MONITORING YEAR 4

MOORES FORK STREAM MITIGATION PROJECT

DMS Project Number 94709

Wildlands Engineering, Inc. (Wildlands) has reviewed the Division of Mitigation Services (DMS) comments from the Draft Monitoring Year 4 report for the Moores Fork Stream Mitigation Project. The following Wildlands responses to DMS's report comments are noted in italics lettering.

Figure 3.4 Integrated Current Condition Plan View (Sheet 4 of 6)
 Moores Fork Stream Mitigation Project
 DMS Project No. 94709
 Monitoring Year 4 - 2019

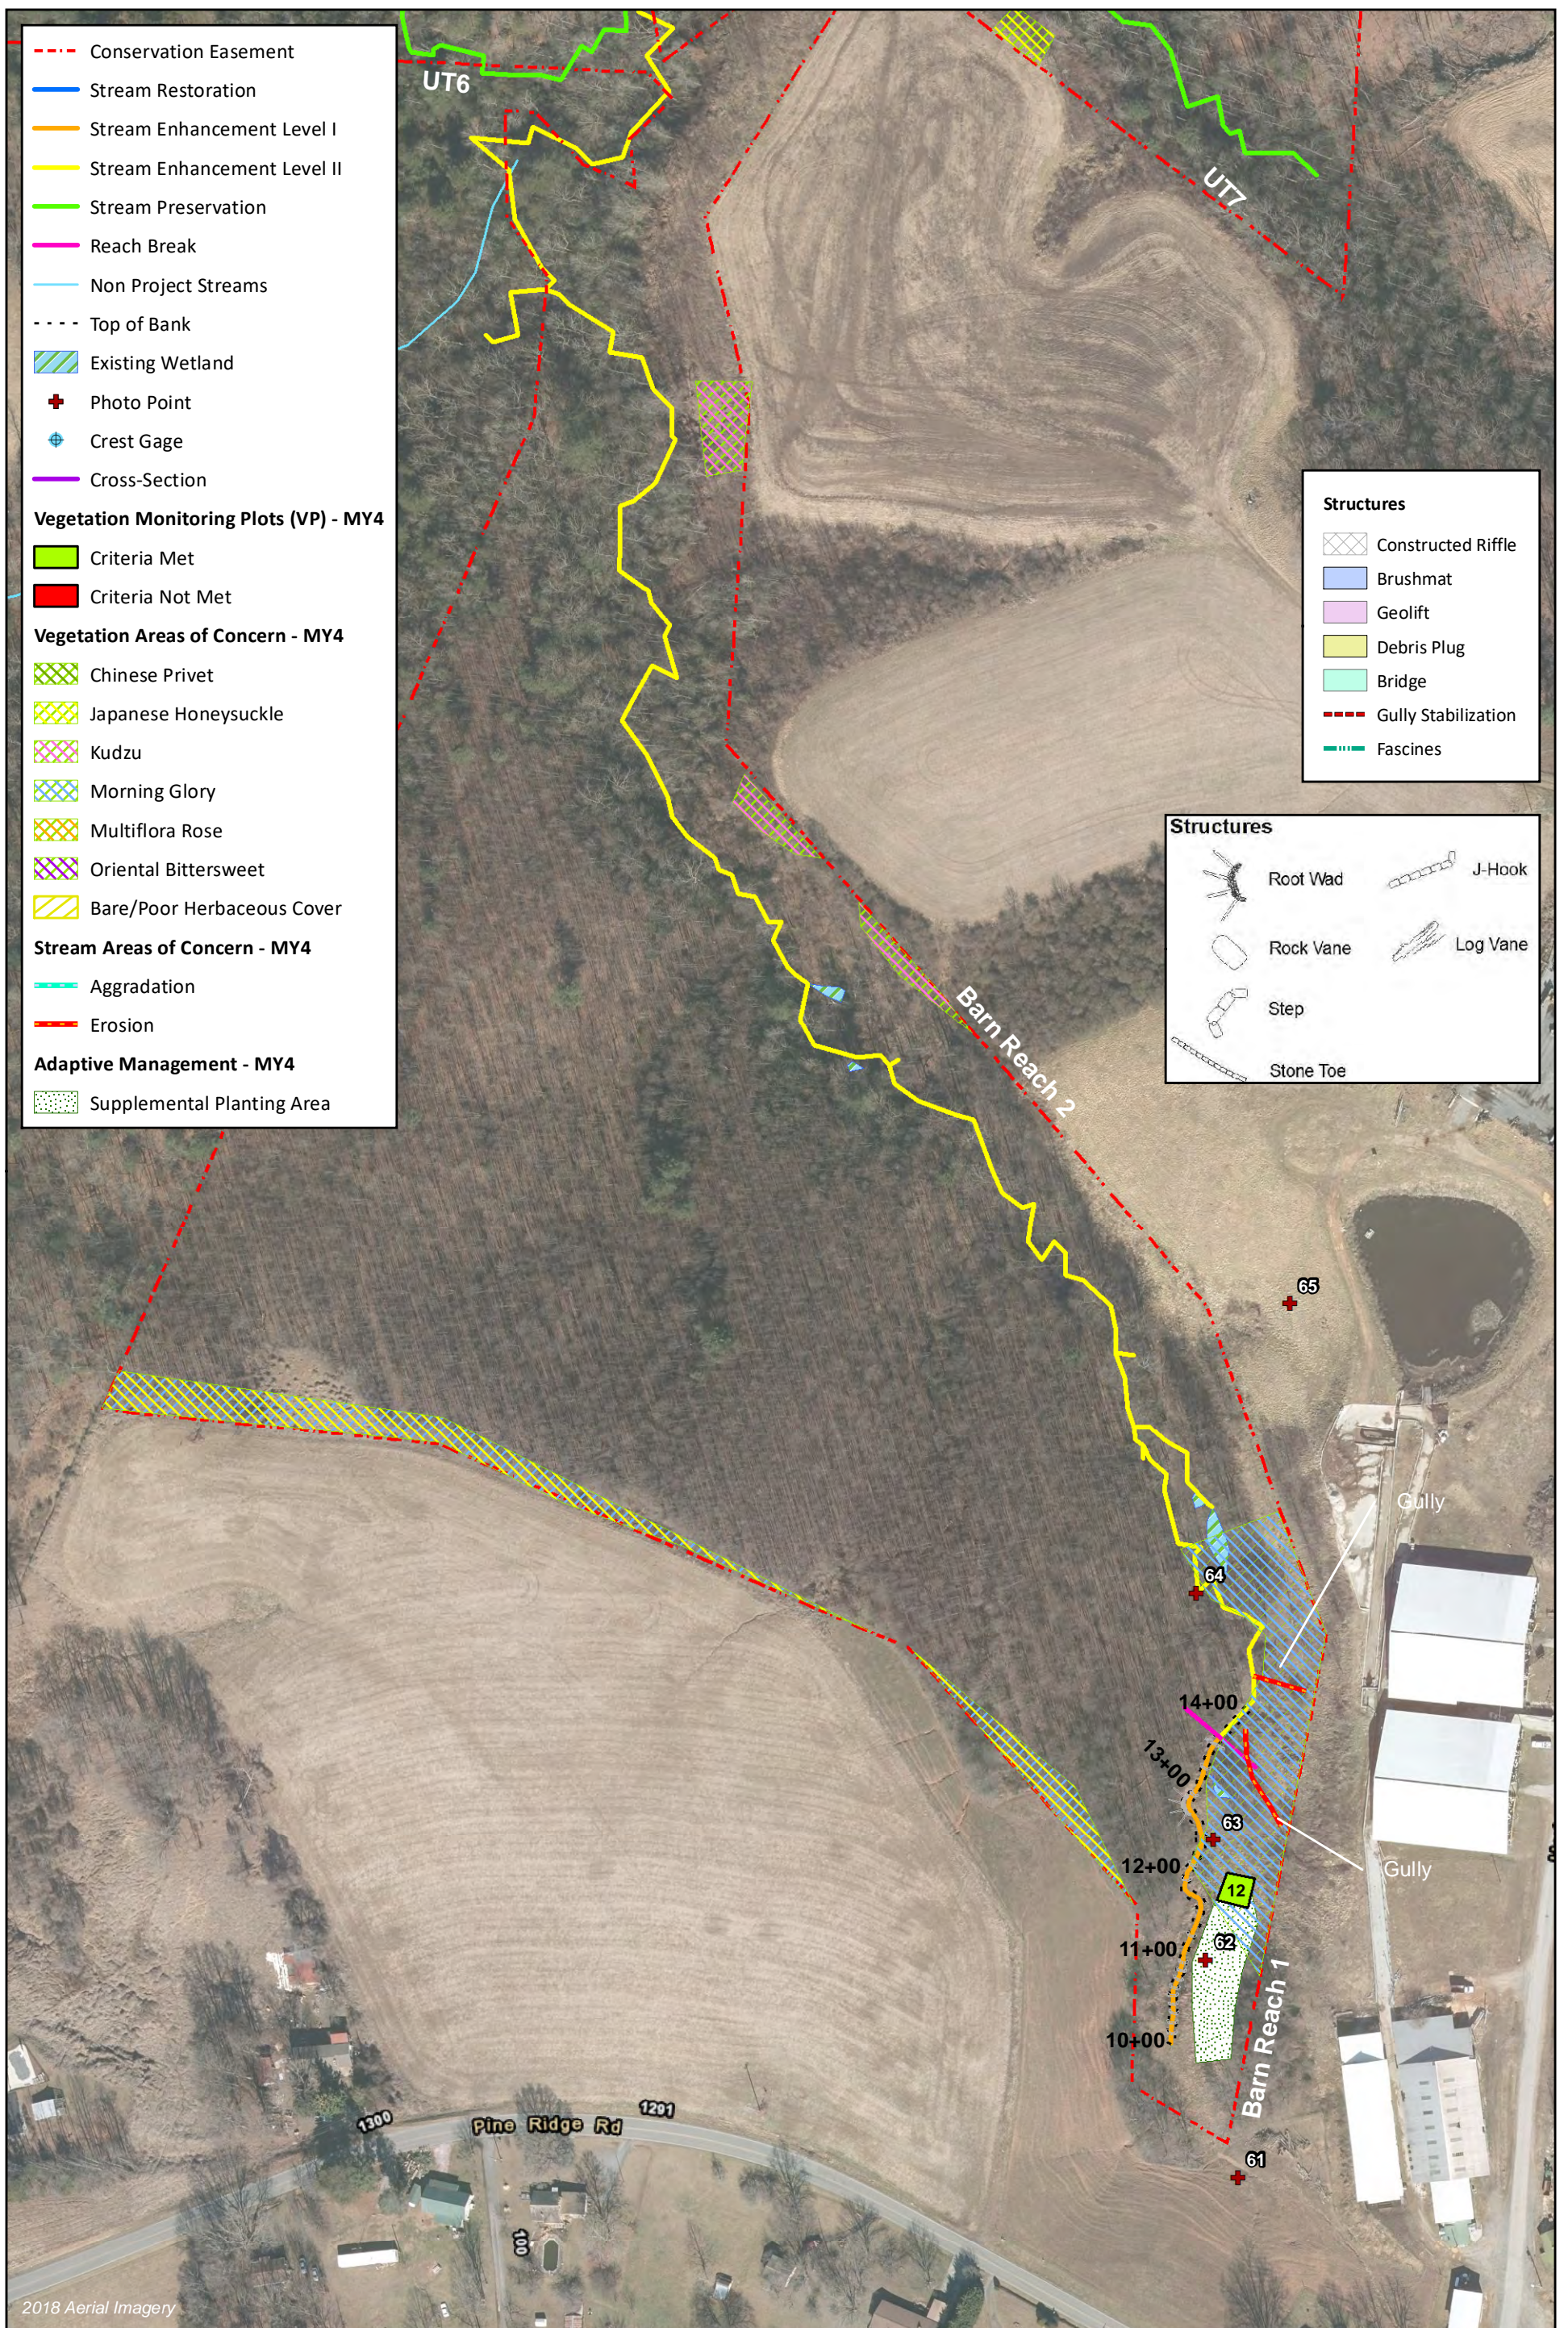
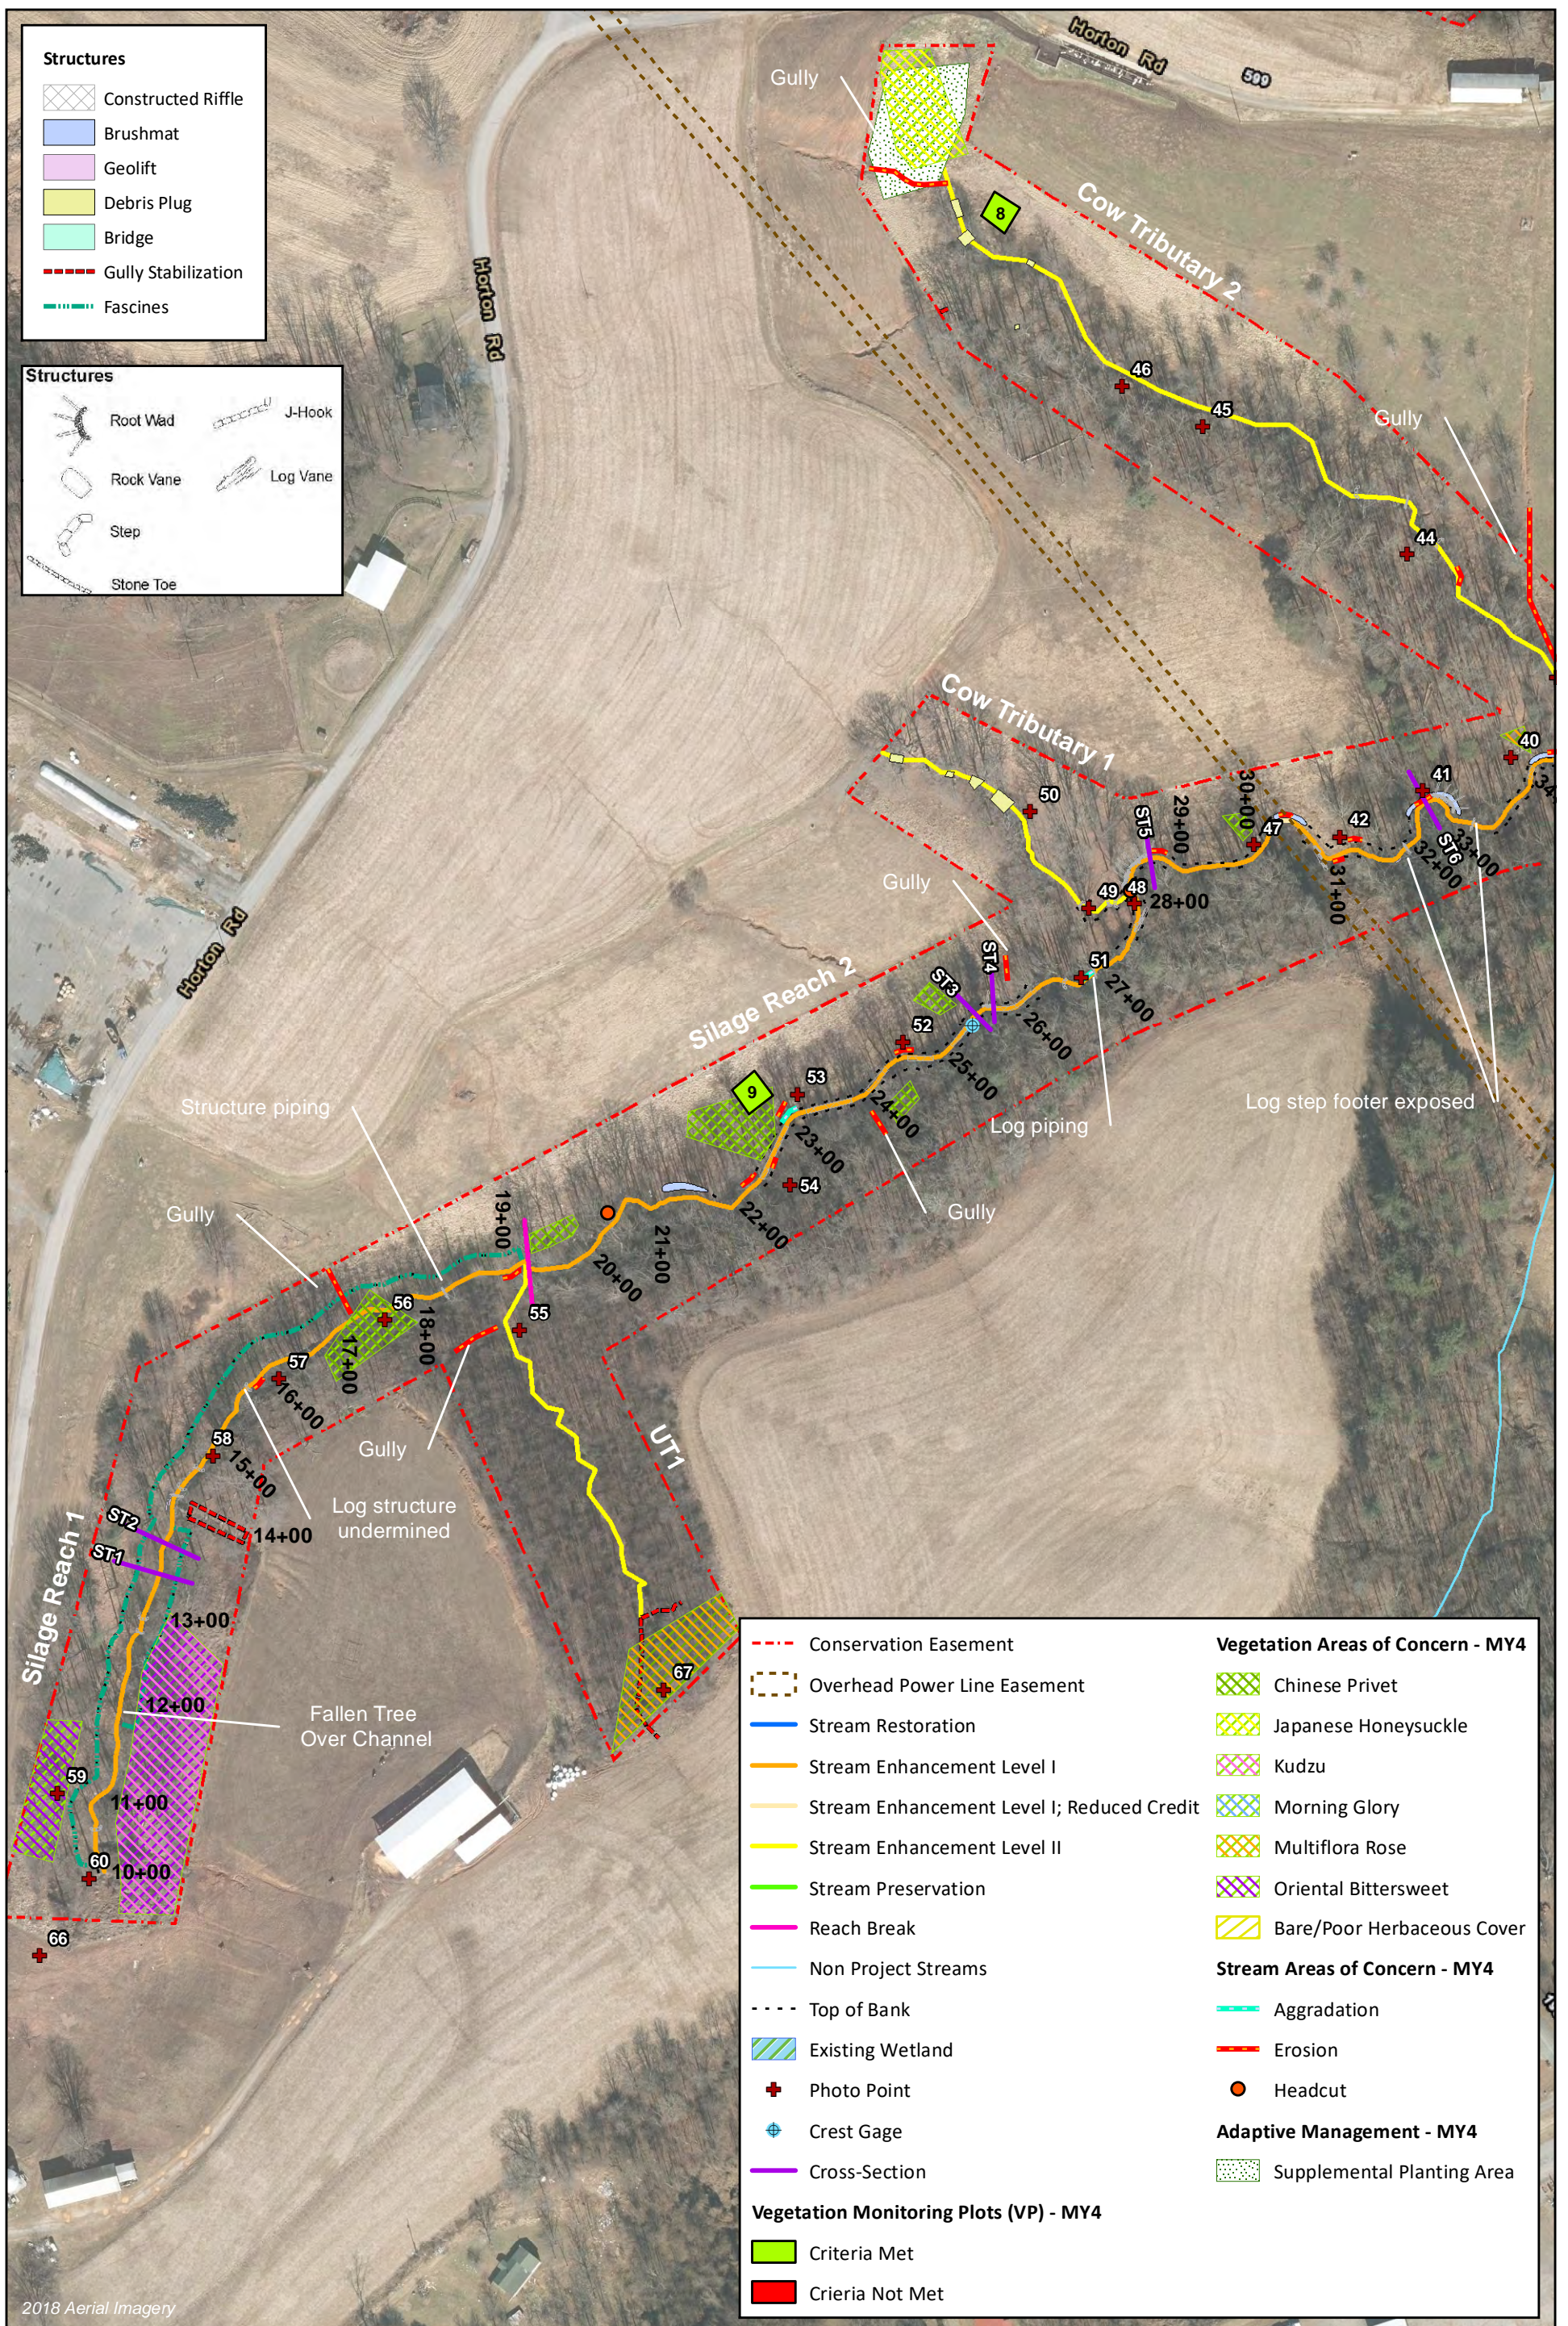
DMS comment; 1.2.2 Vegetation Areas of Concern: The supplemental planting that was completed in March 2019 consisted of 400 bare roots spread across four areas of the site determined to have low stem density based on the MY3 plant warranty inspection report. A pdf of the areas has been included. Please add these areas to the CCPV.

continue to monitor the site for beaver activity through closeout. A map is included with approximate locations of the dams. Please add this to the CCPV.

DMS comment; CCPV: Thanks for providing updated invasive species polygons. Please continue to update as treatment occurs and populations are reduced. This map is a useful tool for the contractor treating the site.

Wildlands response; Text was added to Section 1.2.2 to indicate that 400 bare roots were planted in March 2019. The four areas where supplemental planting took place were added to the CCPV.

Wildlands response; Text was added to Section 1.2.4 to detail the management of beaver activity for the Site in 2019. The approximate locations of the dams were added to the CCPV.

Wildlands response; Wildlands will continue to update the CCPV figures as treatment of invasive species occurs and populations are reduced.
